United States Patent and Trademark Office

APPLICATION NO.	FILING DATE	FIRST NAMED INVENTOR	ATTORNEY DOCKET NO.	CONFIRMATION NO.
10/588,536	08/07/2006	Fernando Garofoli	06170-PCT-PA (0030.0567)	9569
	7590 09/02/2008 sterman and Hattori	•	EXAMINER	
502 Washington Avenue			FULTON, KRISTINA ROSE	
Suite 220 Towson, MD 21204		·	ART UNIT	PAPER NUMBER
10110011, 1112 2			3673	= .
			MAIL DATE	DELIVERY MODE
			09/02/2008	PAPER

DETAILED ACTION

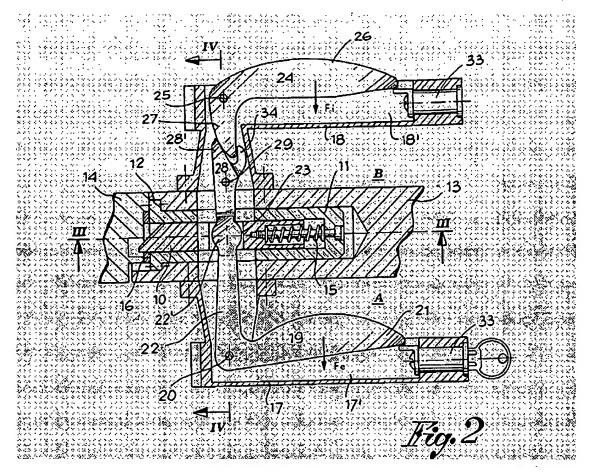
Claims 1-15 are rejected under 35 U.S.C. 102(b) as being anticipated by Pedersoli (DE4009764). "As best understood" Pedersoli shows internal and external handles (17 and 18) having an opening lever (22 or 27) and an opening button (26 or 21). The handle further include a vertical lever (28) having a fork (29). The device includes a spring (15) within a housing (11) and a latch mechanism (10). The door handle further shows a cylindrical chamber (at each end of handle for cylinder 33). The handle includes a cylinder (33) for locking the handle with a key (see illustration below). The handle is an L shape. See the Pedersoli device below.
